FMS Technical Bulletin

Bulletin #FMS003

2026 RH Lidar Holster Mount Update

Date: 8/26/2026

Old mount - holster behind mount point.

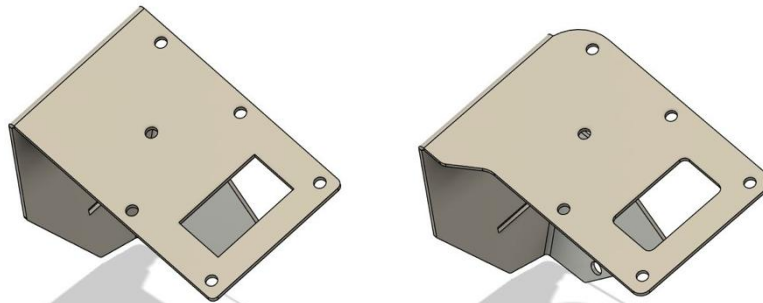
Old mounts look like the ones above.

Complaint: Riders reported that the early Lidar gun holster mounts for 2026 R 1300 RT-P models may alter the path of hot air from the radiator exhaust, causing rider discomfort.

New RH Lidar Holster Mount

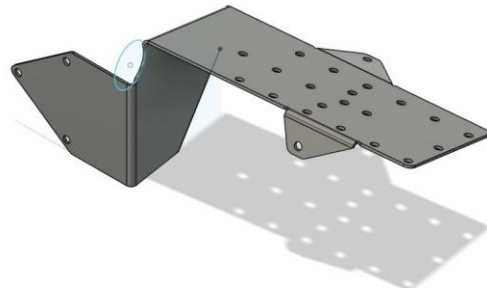
New mount - holster ahead of mounting point

Solution: After extensive testing, a redesigned holster mount was developed for the R 1300 RT-P which moves the holster forward to eliminate disruption of radiator heat exhaust.

Field Solution: Replace early version Lidar gun holster mounts with the new mount. This will eliminate the air deflection, though heat is still exhausted from the radiator.
